Conceptual Review Agenda

Re: Rigden Farm Filing Six, Tract Z - Multifamily

Comment Summary:

Re: 4618 S Mason - Office/Retail

CONCEPTUAL SITE PLAN
 RIDGEN FARMS, TRACT Z, FILING SIX
 FORT COLLINS, COLORADO
 2013

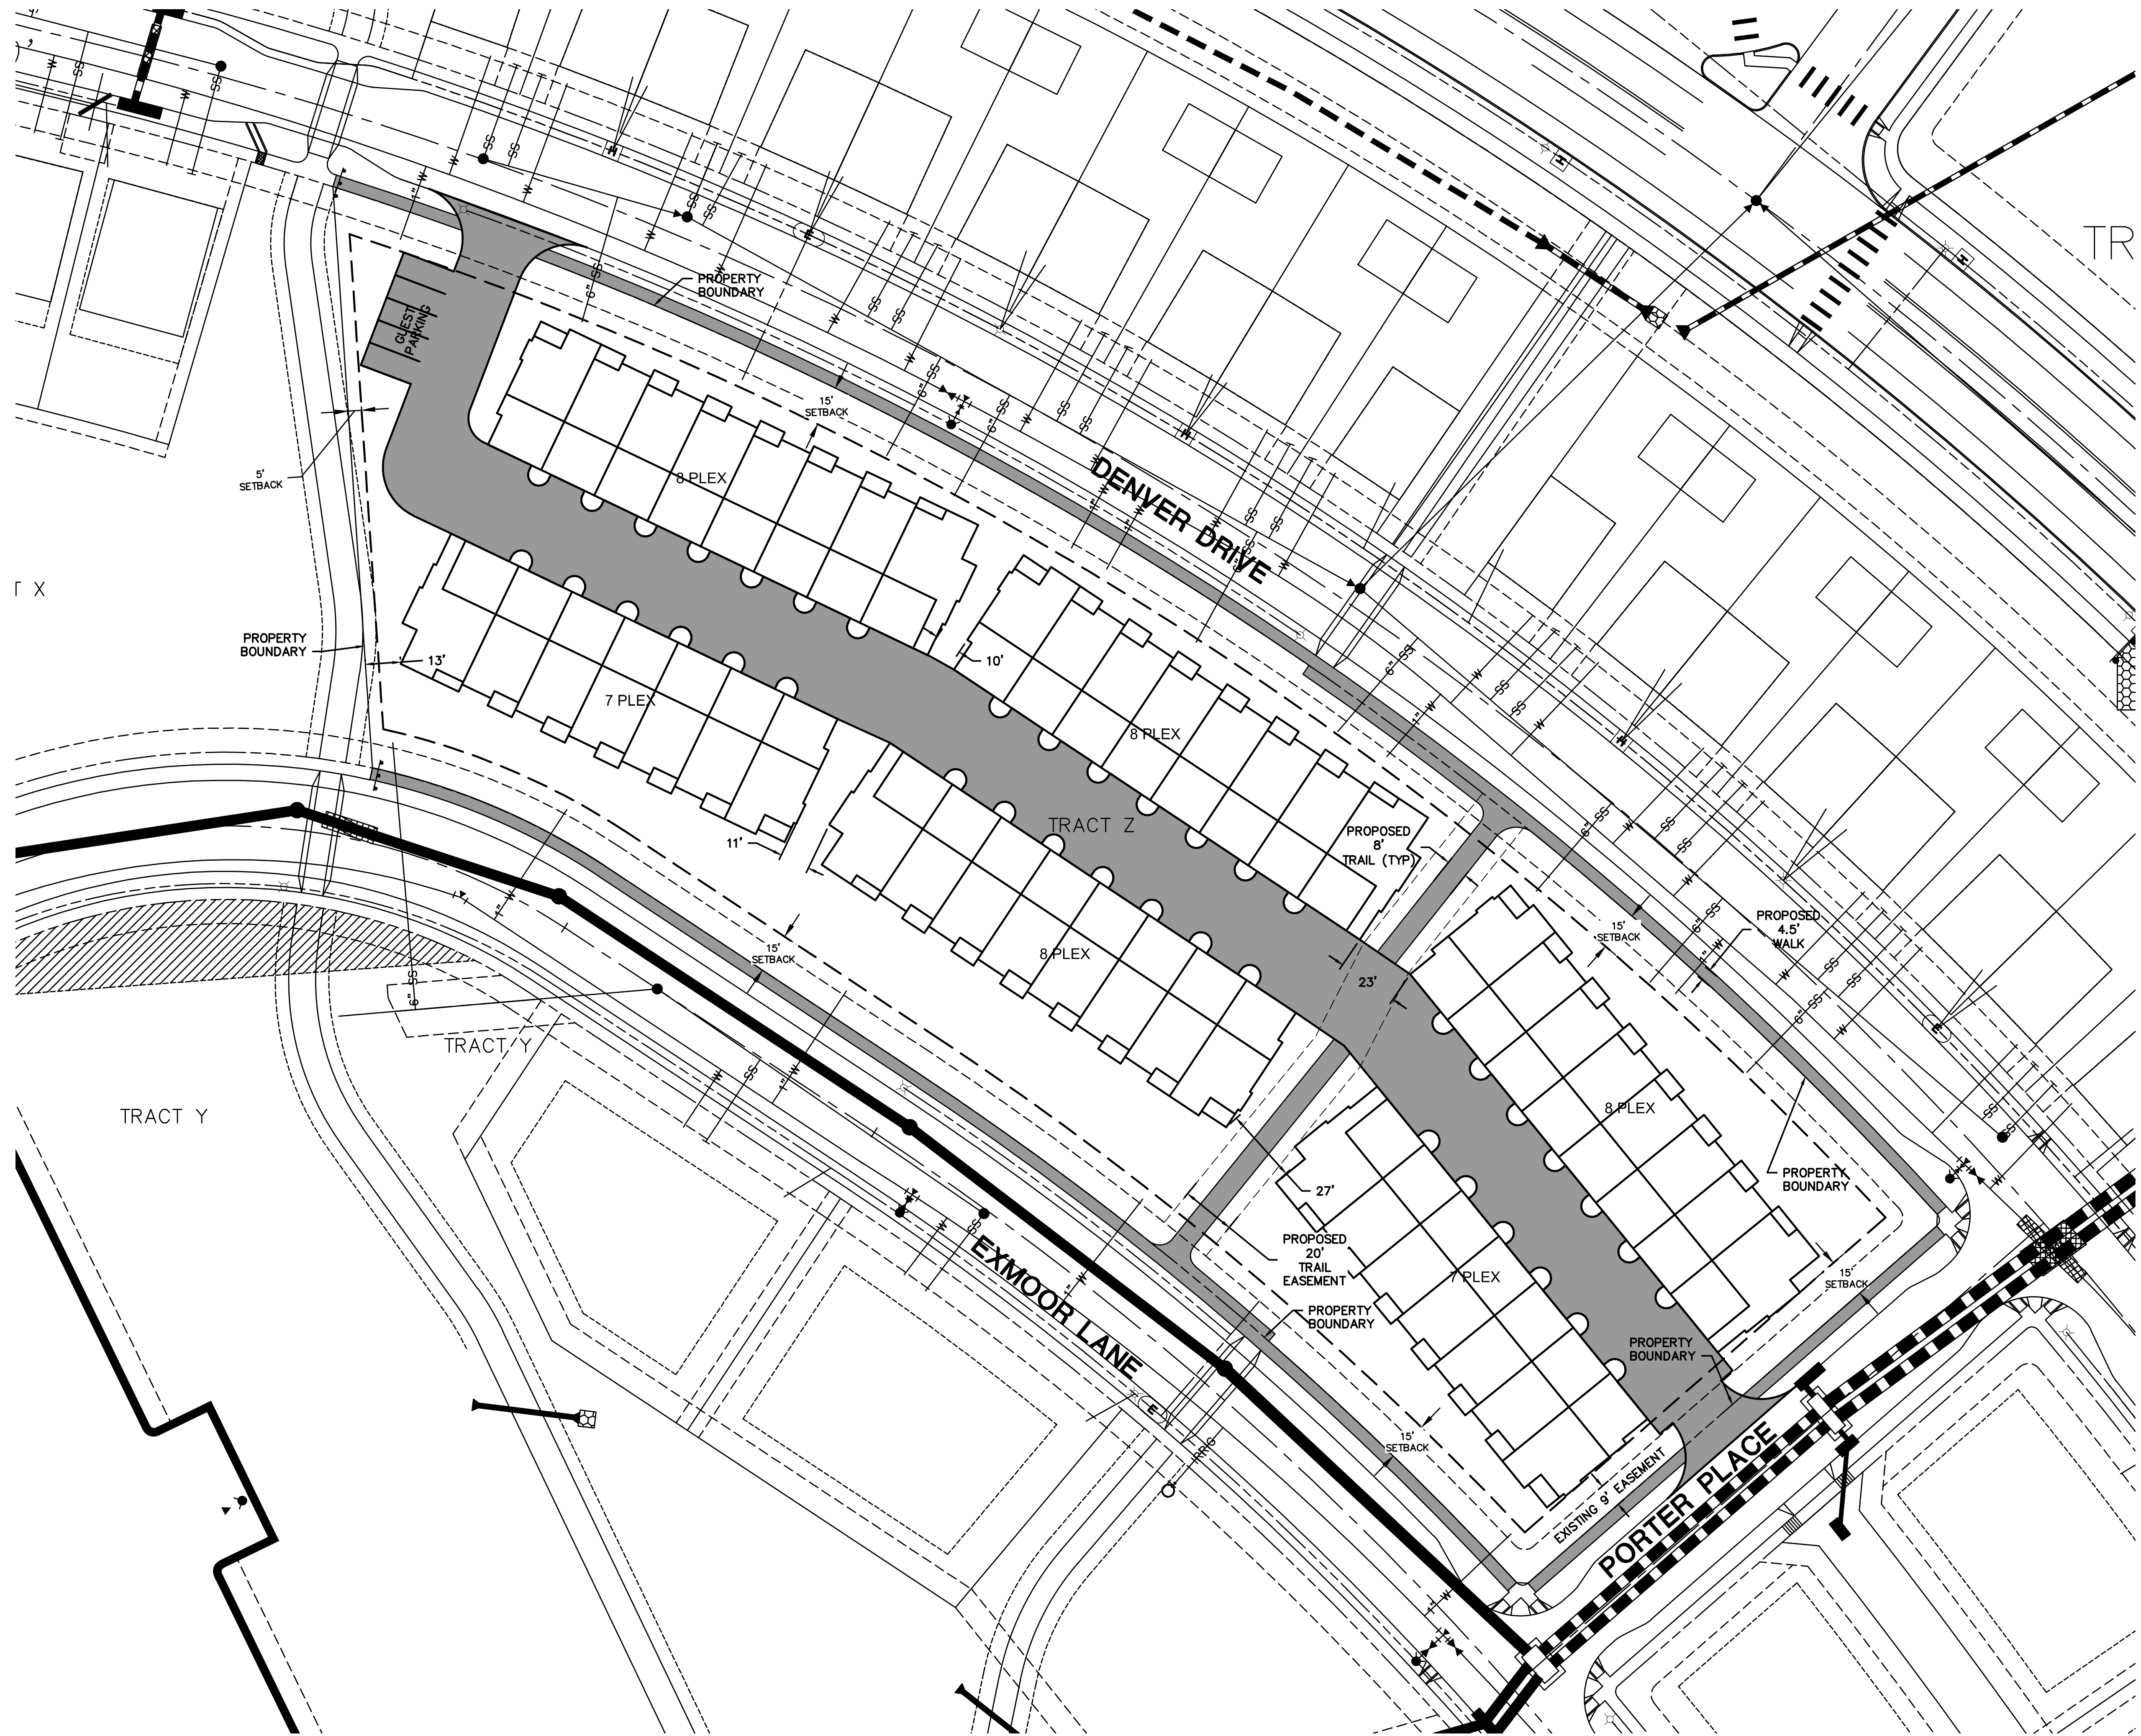
1. Based on the site plan submitted it appear there are 46 units as opposed to the 49 units in the project description.
2. The overall density of Rigden Farm 6th would be taken for the min. density requirements in the LMN zone which is 9 dwelling units per acre. The plat indicates the square footage of Tract Z at 128,525 s.f.
3. Without additional information no further comments.

6. This project is responsible for dedicating any right-of-way and easements that are necessary for this project. The proposed pedestrian trail connection through the property falls outside of the existing easement. A new easement and vacation of the existing easement will be required. Are you planning on a replat of the property? Easements can be dedicated and vacated by replat or by separate document.

9. A Development Construction Permit (DCP) will need to be obtained prior to starting any work on the site.
10. The proposed access point off of Porter Place will need to align with the existing driveway to the south east

11. LCUASS parking setbacks will apply for the proposed access point off of Denver Dr. Refer to LCUASS figure 19-6 for current parking setback requirements.

1. The maximum density for LMN as part of a phased development is 12 unites per acre. It appears that the +/- 2.95 acre tract concept is at 15.6 du/ac with the 46 units and is over the maximum density.

7. Please note that the minimum drive isle width per 3.2.2(L) is 28' clear where garages front the isle.
8. The units proposed are two story. If it is later decided that the units will be three story, or if they are configured in buildings with more than 8 units per building, then the following standards will apply: Design Standards for Multi-Family Dwellings Containing More Than Eight (8) Dwelling Units and for Multi-Family Dwellings Containing between Four (4) and Eight (8) Dwelling Units When Three (3) or More Stories in Height. Each multi-family dwelling containing more than eight (8) dwelling units and each multi-family dwelling containing between four (4) and eight (8) dwelling units, when located in a building of three (3) stories in height, shall feature a variety of massing proportions, wall plane proportions, roof proportions and other characteristics similar in scale to those of single-family detached dwelling units, so that such larger buildings can be aesthetically integrated into the low density neighborhood. The following specific standards shall also apply to such multi-family dwellings:

11. Sidewalks shall be provided from the street to the entrance of each unit. Given the setback distance in some areas of the plan, it is recommended that sidewalk approaches are grouped for multiple units so that a "runway" appearance of long multiple sidewalk strips is avoided.

PROPOSED USE

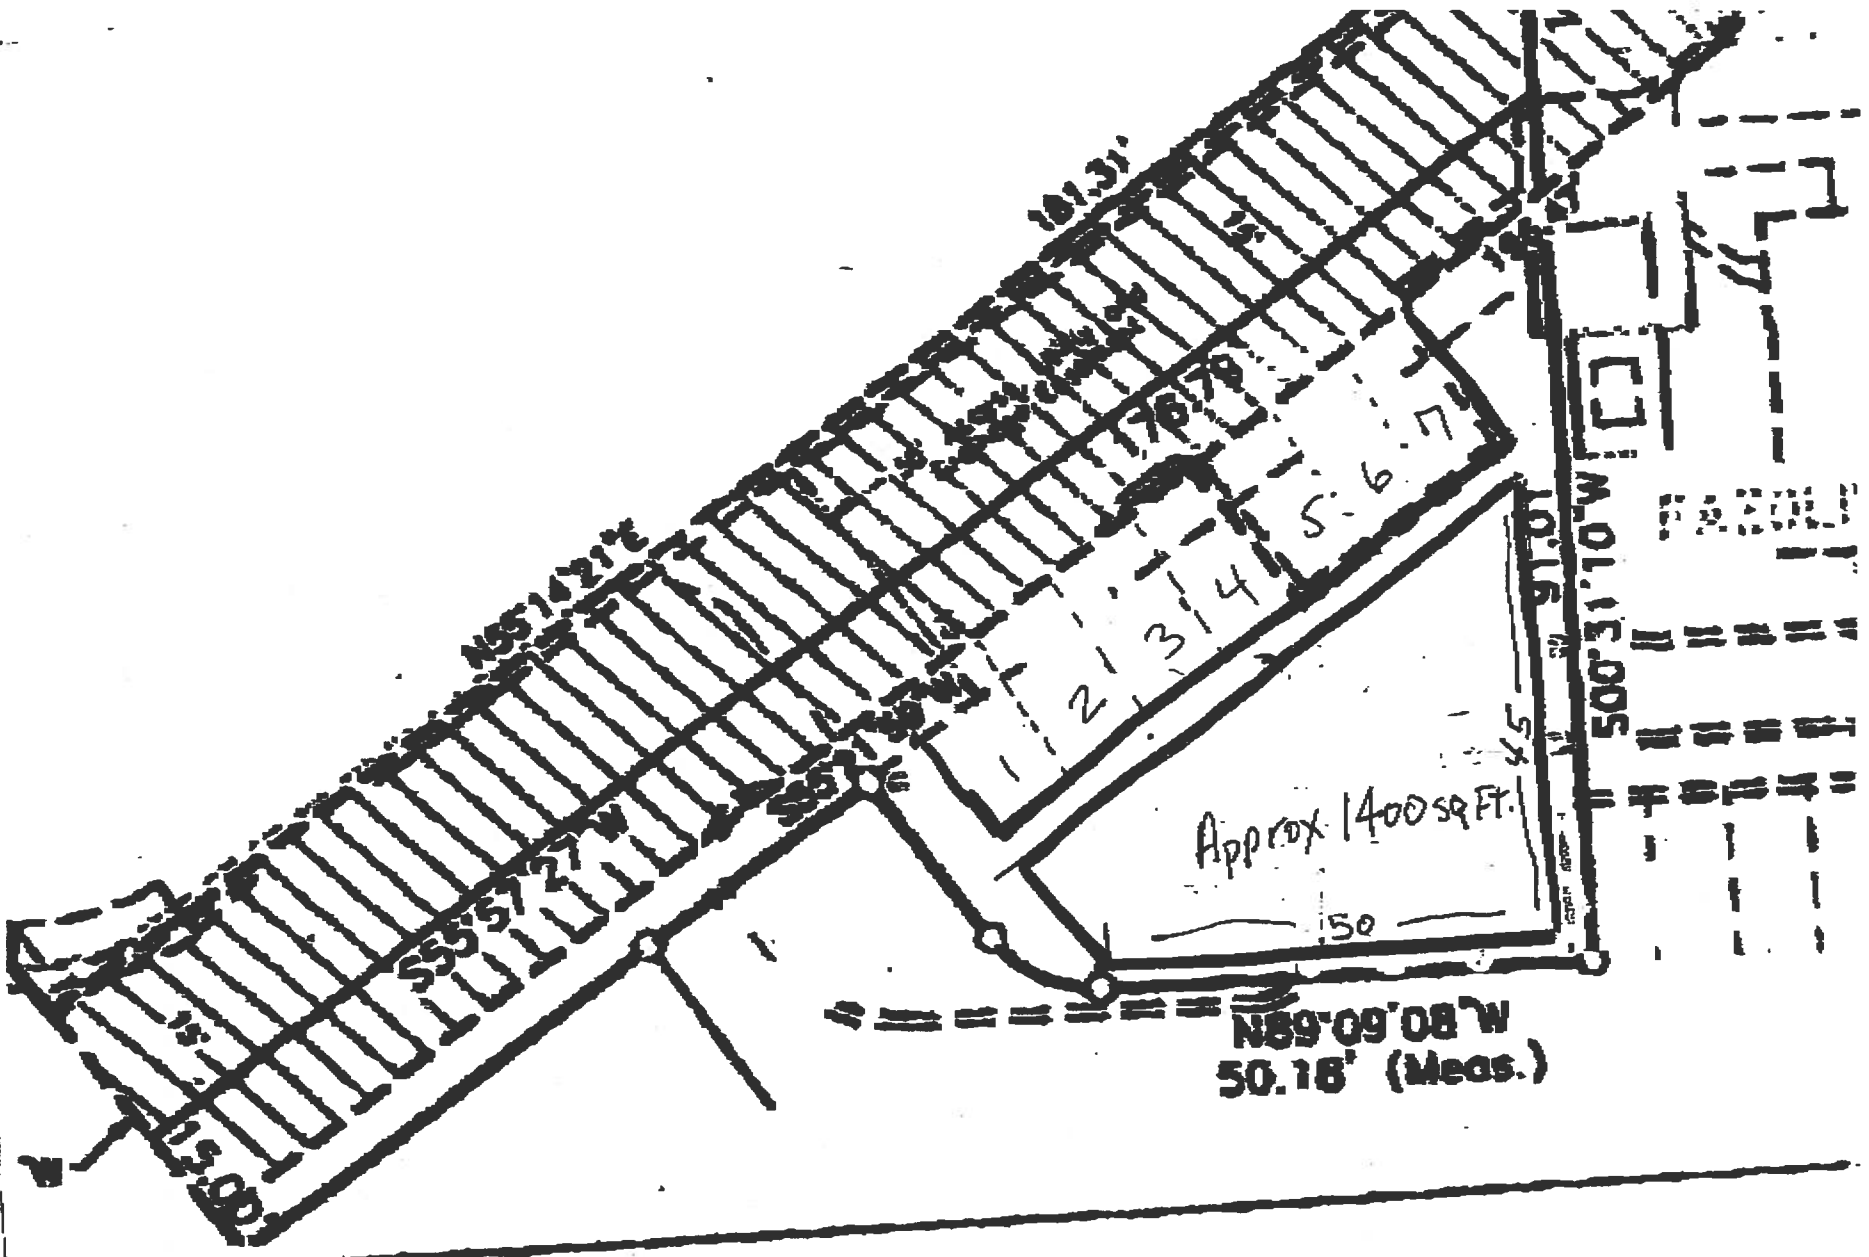
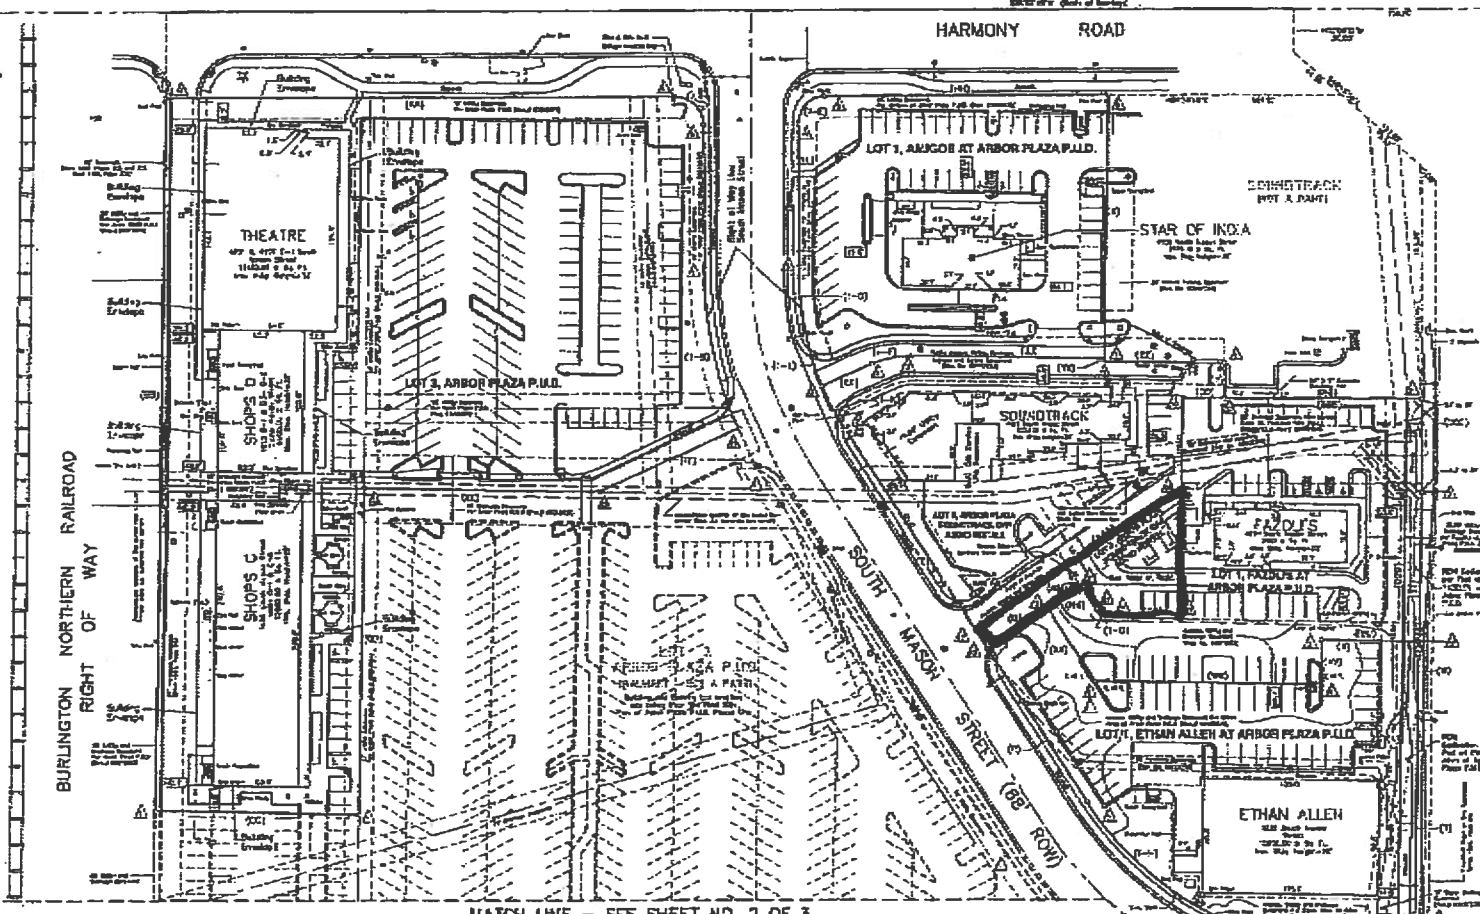
1. The legal description is Lot 2 of Arbor Plaza Soundtrack Car Audio Install.
2. The plan clearly impacts the Fazoli's site including their drive up lane which would have to be eliminated at it's west end thus requiring a separate route.
3. Backing out of a parking stall on to the 30' wide pvt. street doesn't appear safe.
4. Sharing of trash enclosures may be necessary on this tight site.

8. A Development Construction Permit (DCP) will need to be obtained prior to starting any work on the site.
9. The proposed site plan appears to be blocking the Drive Thru access for the existing Fazoli's restaurant. Looking at the approved plats for these lots it does not appear that there was an access easement dedicated across this projects lot to provide access to the Drive Thru. If there is such an easement that was dedicated independently of the plats than it should be provided and included on the site plan. Is there any

plans for Fazoli's to continue to take drive thru access through another adjacent lot?

1. The building will need to comply with Section 3.5.3 which describes the design standards for commercial buildings.
2. Adding a new building to a shopping center would be considered a Major Amendment. According to the Land Use Code, Major Amendments to approved development plans or site specific development plans approved under the laws of the City for the development of land prior to the adoption of this Land Use Code shall be processed as required for the land use or uses proposed for the amendment as set forth in Article 4 (i.e., Type 1 review or Type 2 review) for the zone district in which the land is located, and, to the maximum extent feasible, shall comply with the applicable standards contained in Articles 3 and 4." Please note that Section 3.2.2, Access Circulation and Parking, requires that the parking and circulation aspects of all developments are well designed with regard to safety, efficiency and convenience for vehicles, bicycles, pedestrians and transit both within the development and to and from surrounding areas. As proposed, the blocking of the existing Fazoli's drive-through lane would violate this standard. To remedy this deficiency, please work with Fazoli's to provide an alternative drive-through lane location that is acceptable to all parties.
